EVANS  
TAYLOR  
FOSTER  
CHILDRESS  
ARCHITECTS  
343 North Main Street  
Memphis TN 38103

**ADDENDUM NO. 3**  
**March 8, 2024**

**FIRE STATION # 1**  
**City of Marion**  
**Marion, AR 72364**

ENLARGED PLANS AND  
INTERIOR ELEVATIONS  
Drawing Number:  
**A5.2**  
Date: September 29, 2023  
Project Number:  
22207

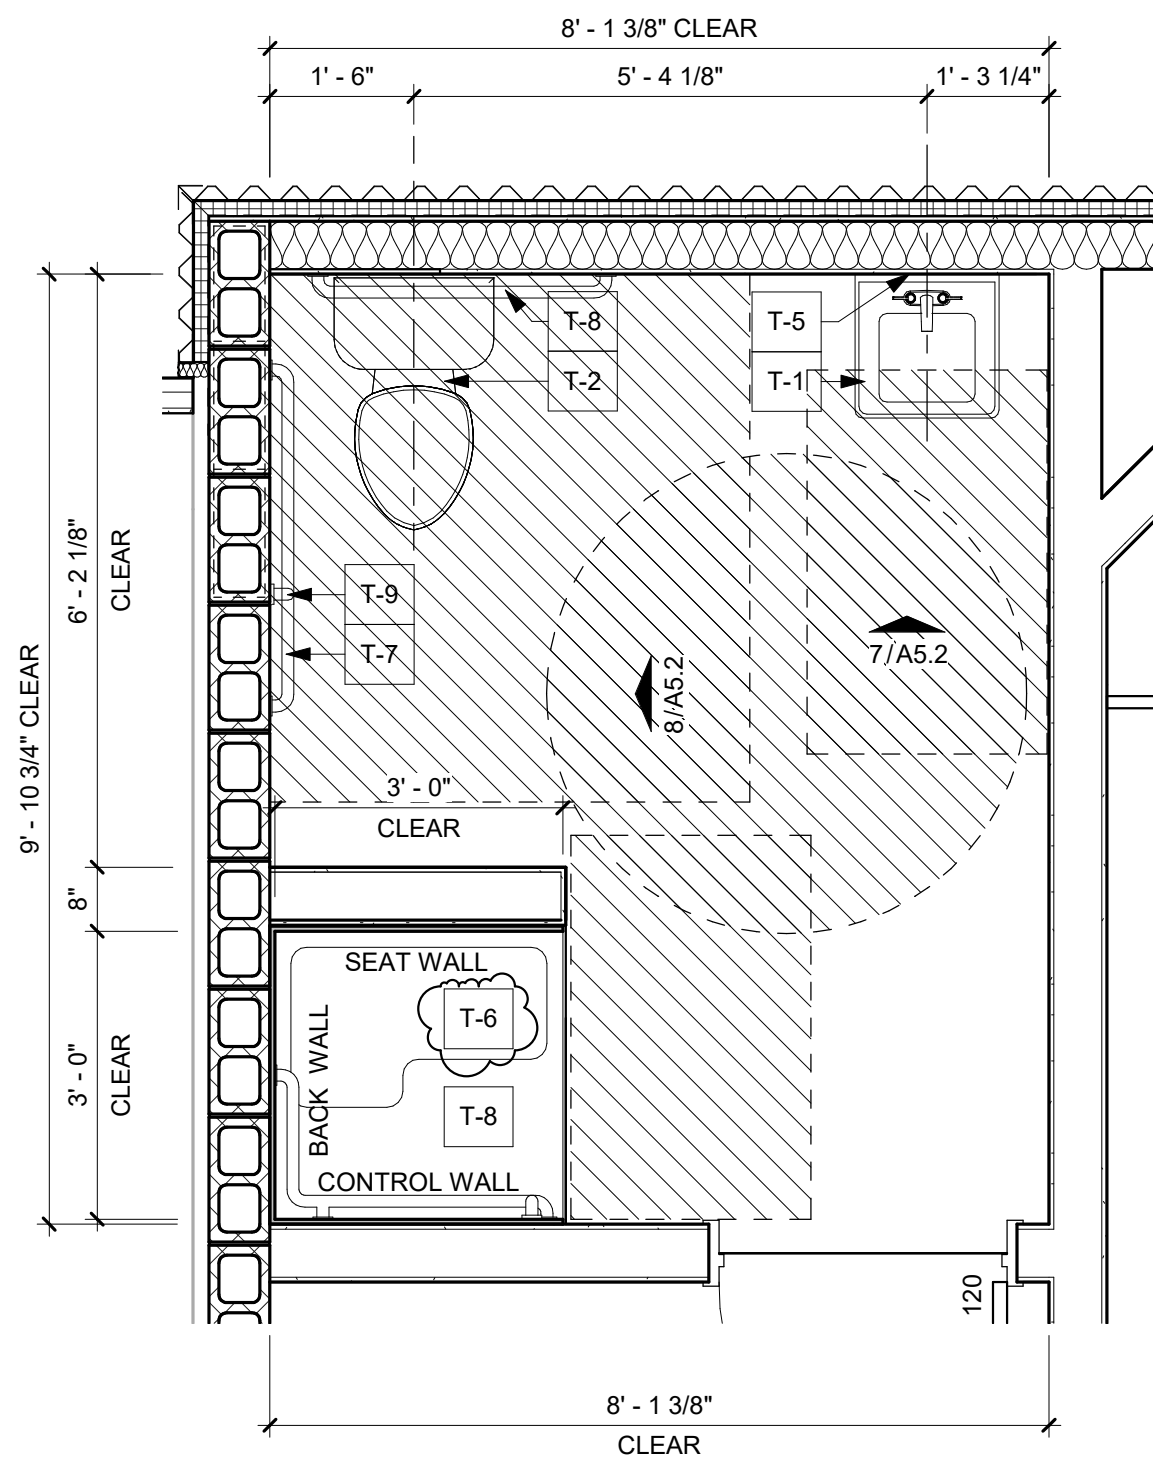
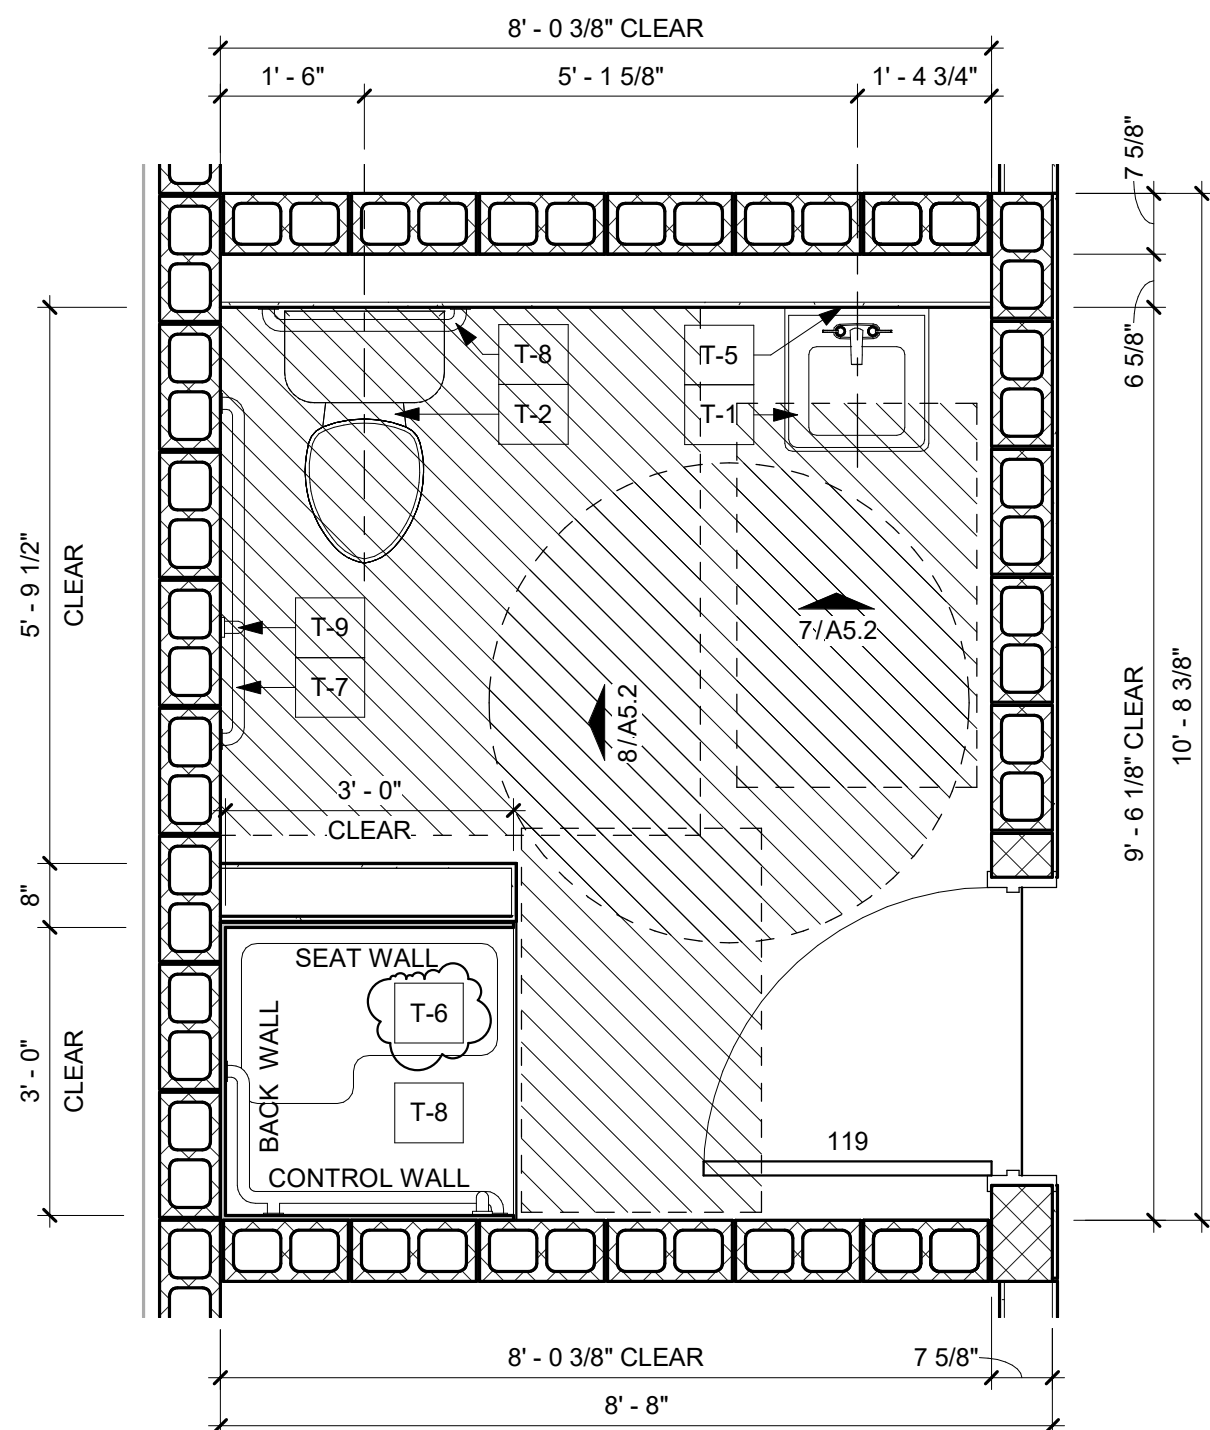
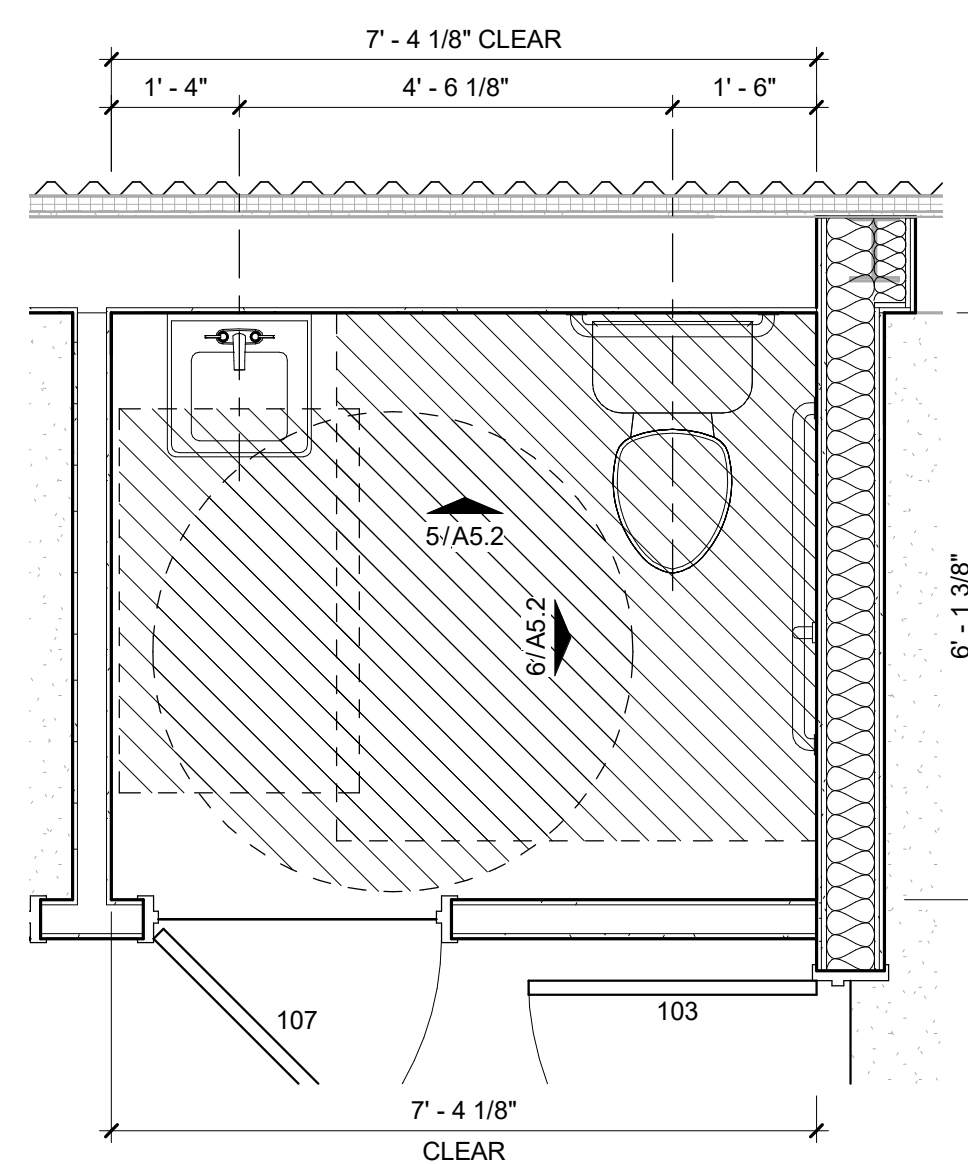
A5.2 Revised mark "T-6" on Toilet Accessory Schedule. Added "T-6" mark to 4/A5.2 and 3/A5.2 for clarification.

Drawing Number:  
**A6.1**  
Date: September 29, 2023  
Project Number: 22207

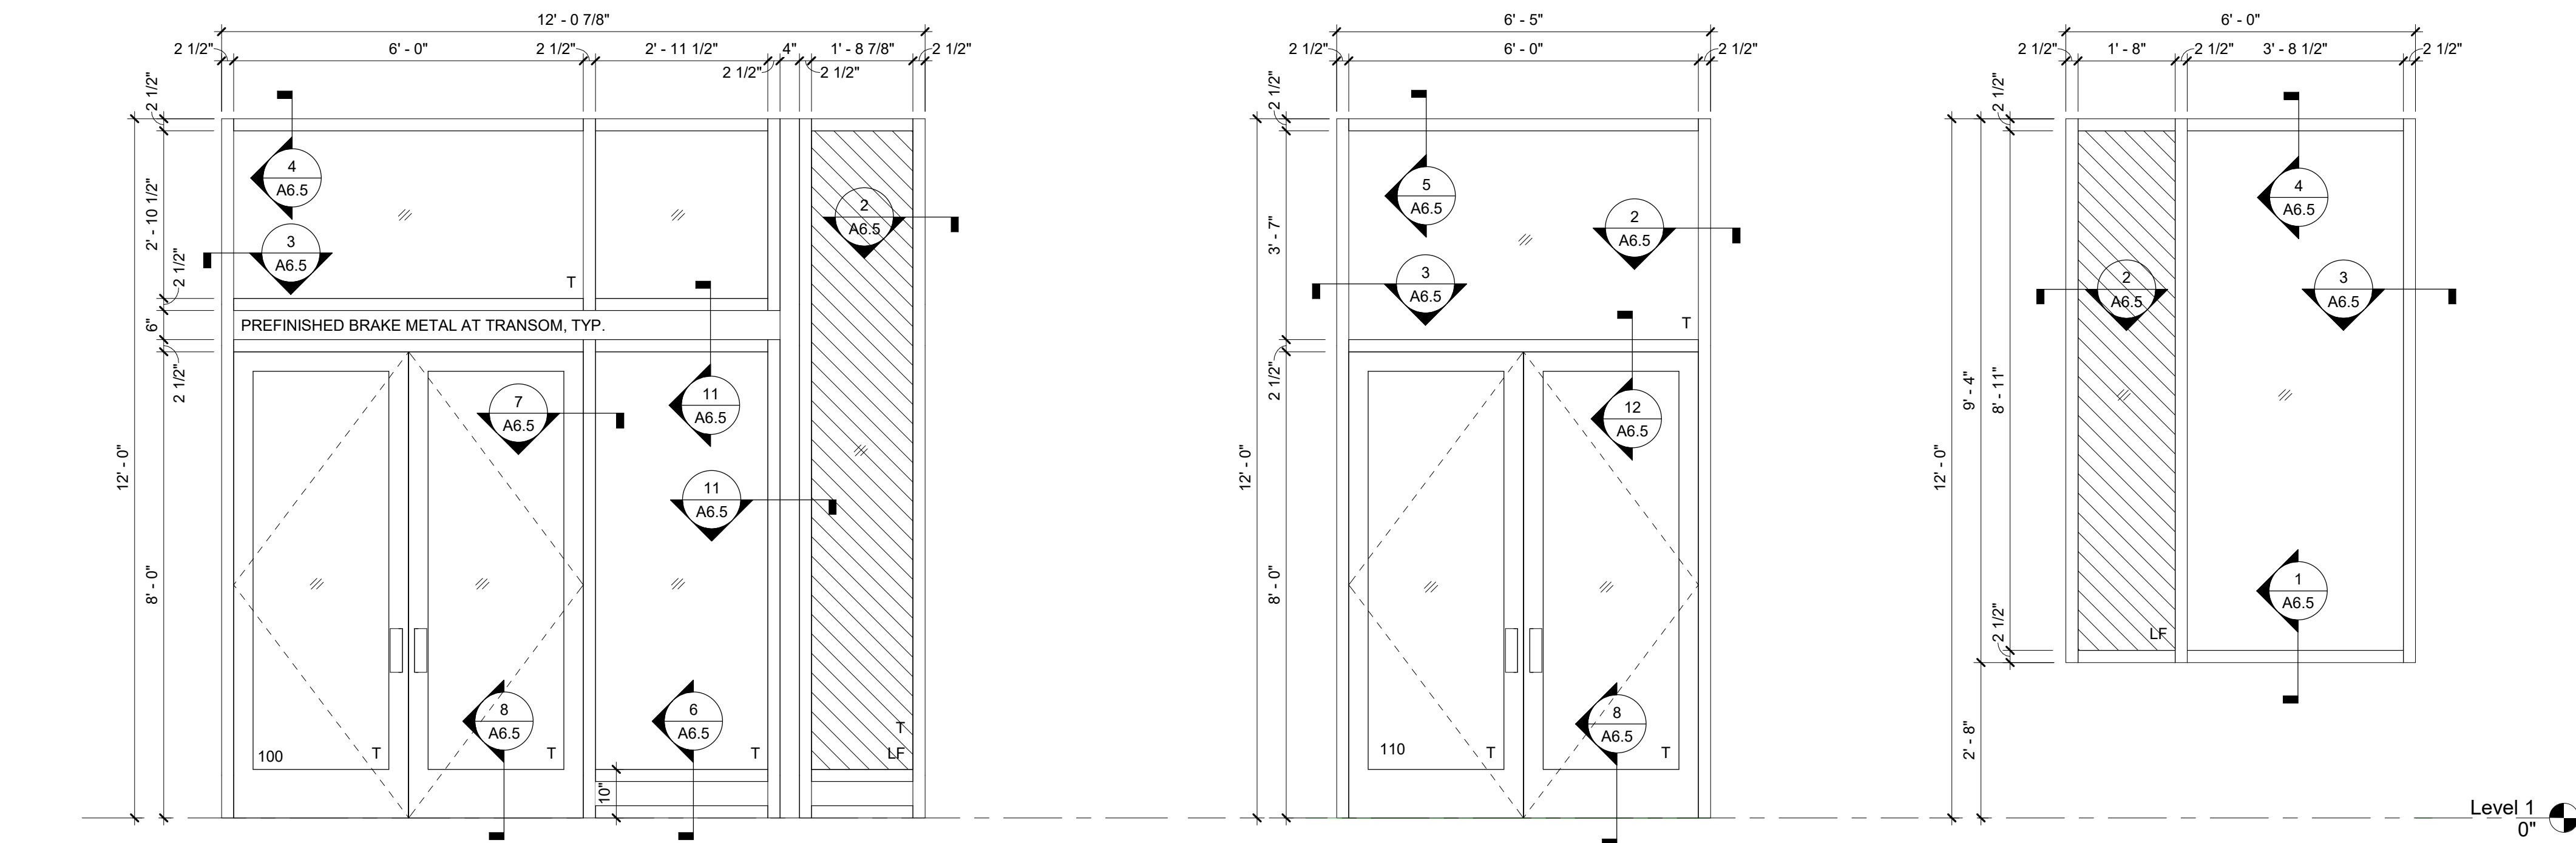
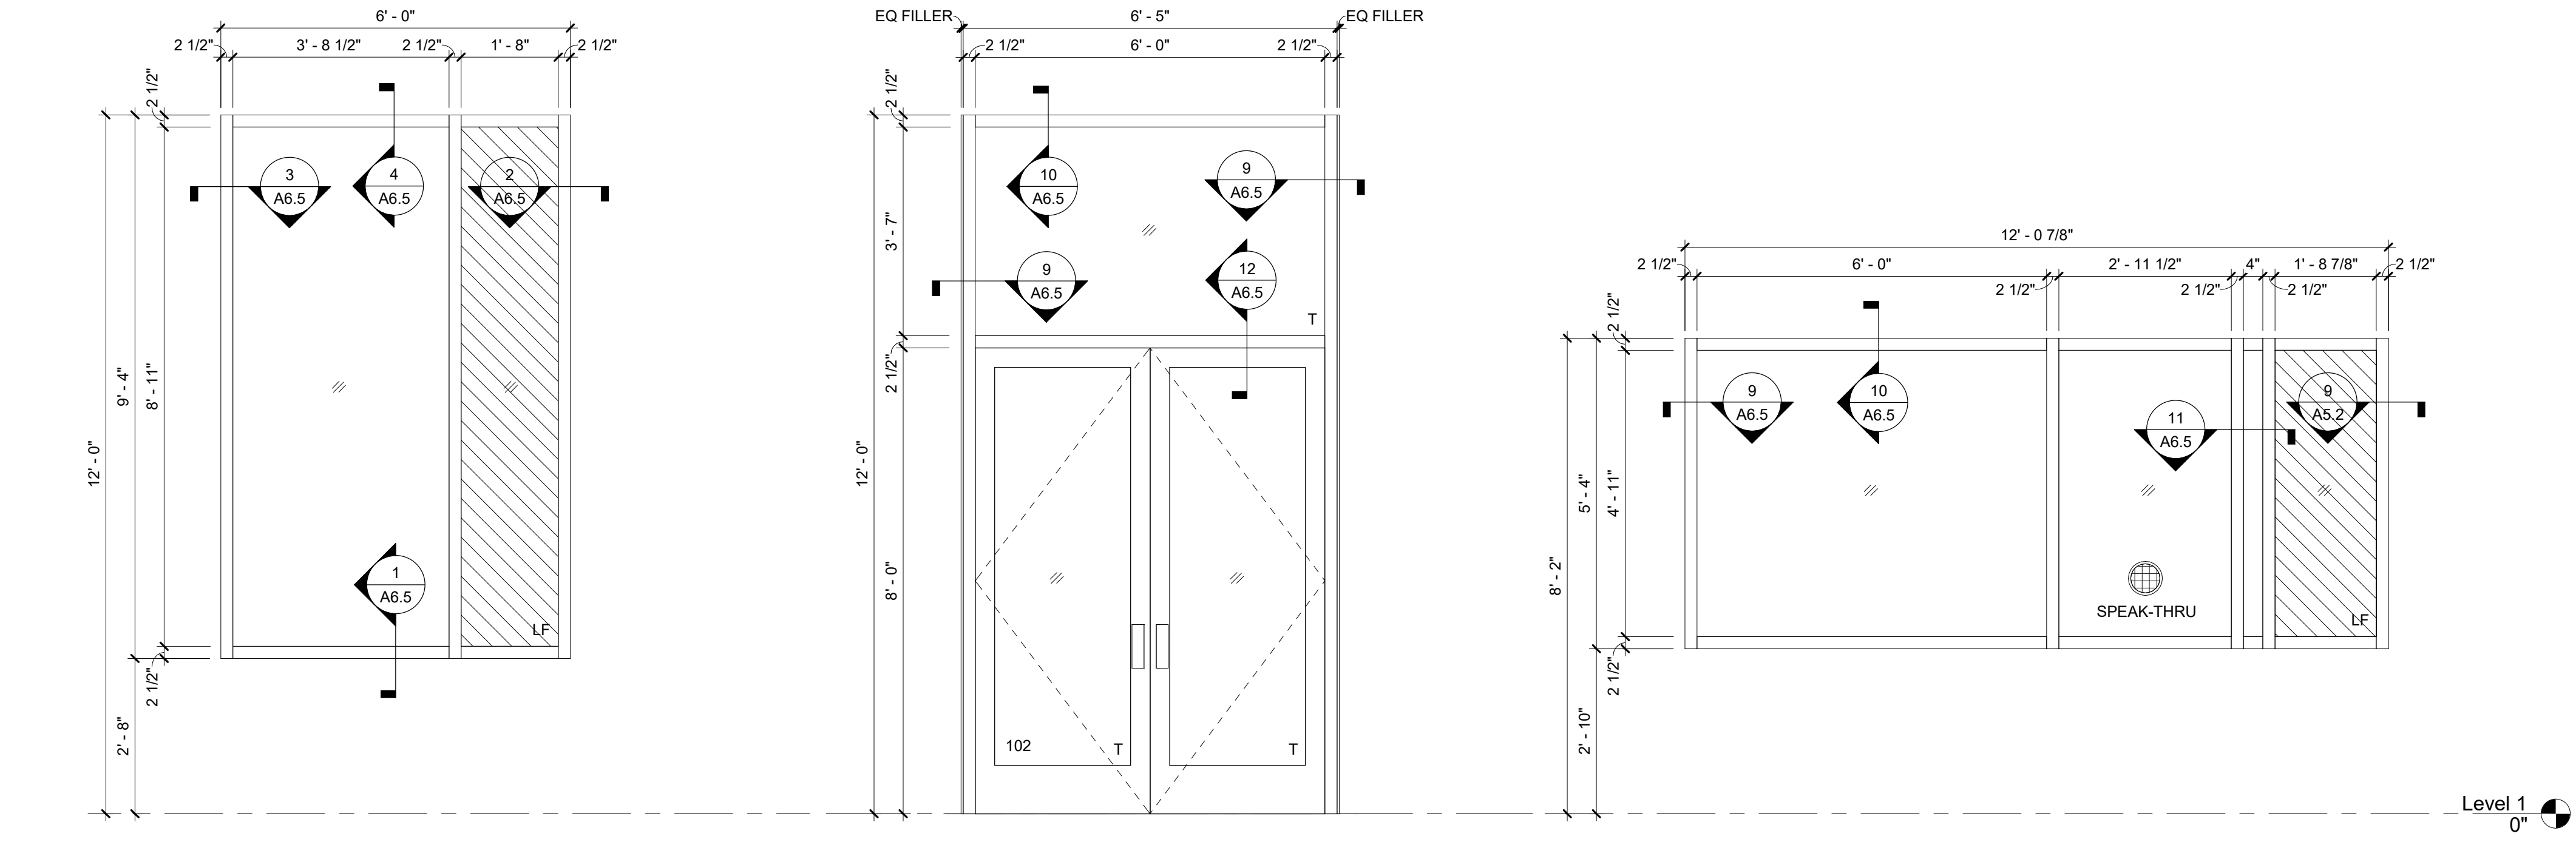
A6.1 Revised Room Finish Schedule at [108] Apparatus for Add Alternate 1. Revised Room Finishes at Sun Shades for style/material clarification.
